HKAL Body Rail Clip Relocation

BODY RAIL CLIP RELOCATION VANTRAAX® HKAL

LIT NO: P36015

DATE: December 2015

OLD CLIP LOCATION

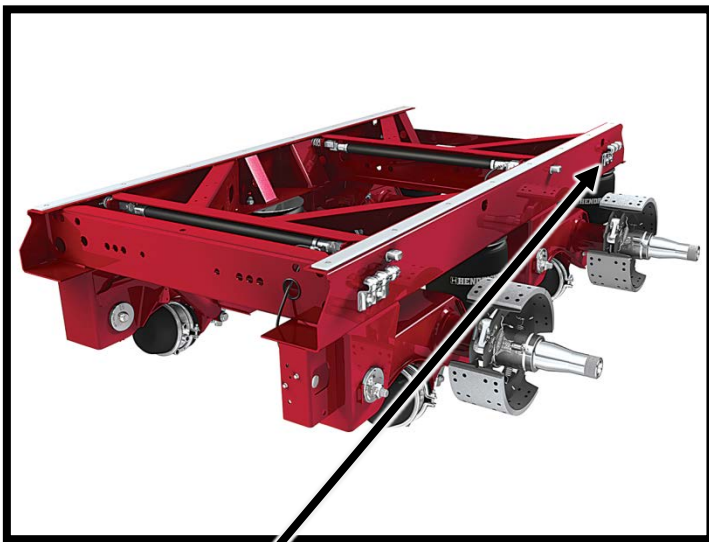
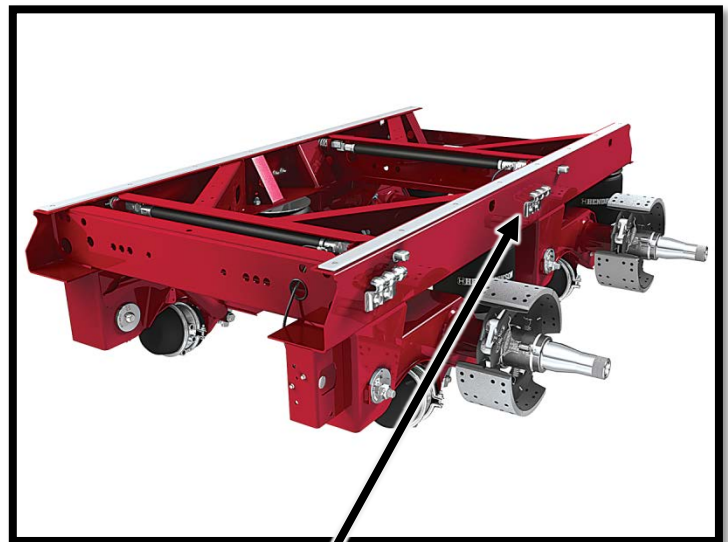
Hendrickson Trailer Commercial Vehicle Systems announces a change to VANTRAAX® HKAL low-ride air slider systems. With shipments beginning in December 2015, HKAL models will feature body rail clips located in a more forward position on the slider box assembly.

This change has been implemented to provide increased tire clearance. The fit, form and function of the body rail clips remain unchanged; only the location of the clips will change. VANTRAAX model numbers and aftermarket service part numbers are unaffected by this change.

NEW CLIP LOCATION
